**UN Regulation No. 79 (Steering equipment):**

**Automatically Commanded Steering Function**

**Proposal for a Supplement to the 03 series of amendments to  
UN Regulation No. 79 (Steering equipment)**

**Submitted by the experts from the International Organization of Motor  
Vehicle Manufacturers and the European Association of Automotive  
Suppliers\***

2.1.2.1. General

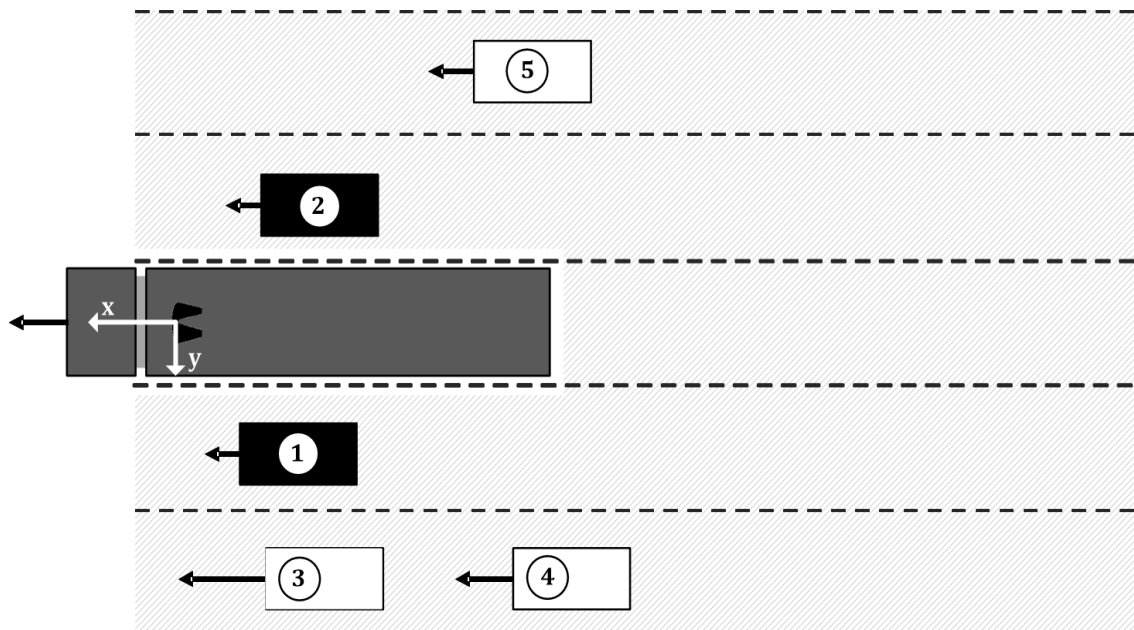
**IMPORTANT** — If ISO 11992-1 is used as a data link and physical layer only one trailer (towed vehicle) can be supported due to bandwidth overload of the CAN bus between towing and towed vehicles.

The towing vehicle shall not rely on any sorting of the objects communicated by the towed vehicle.

2.1.2.3. Objects behind the towed vehicle

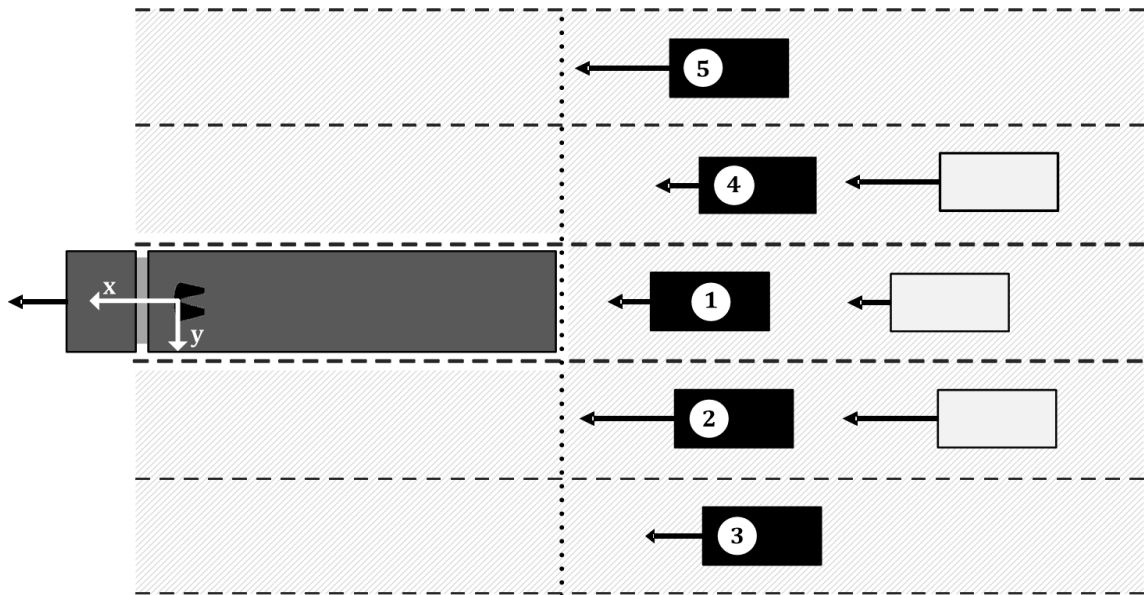
The area behind the towed vehicle is split into five ranges. From each range an object shall be selected, if present. If the absolute velocity of the towed vehicle > 10 km/h only moving objects shall be selected. An object is moving if its absolute velocity is not zero. The five ranges are specified by the lateral position relative to the towed vehicle:

- (a)  $-0.5 \times w - 7 \text{ m} \leq y < -0.5 \times w - 3.5 \text{ m}$
- (b)  $-0.5 \times w - 3.5 \text{ m} \leq y < -0.5 \times w$
- (c) behind the towed vehicle
- (d)  $0.5 \times w < y \leq 0.5 \times w + 3.5 \text{ m}$
- (e)  $0.5 \times w + 3.5 \text{ m} < y \leq 0.5 \times w + 7 \text{ m}$

Where  $y$  is the lateral position [m] and  $w$  is the width [m] of the towed vehicle.
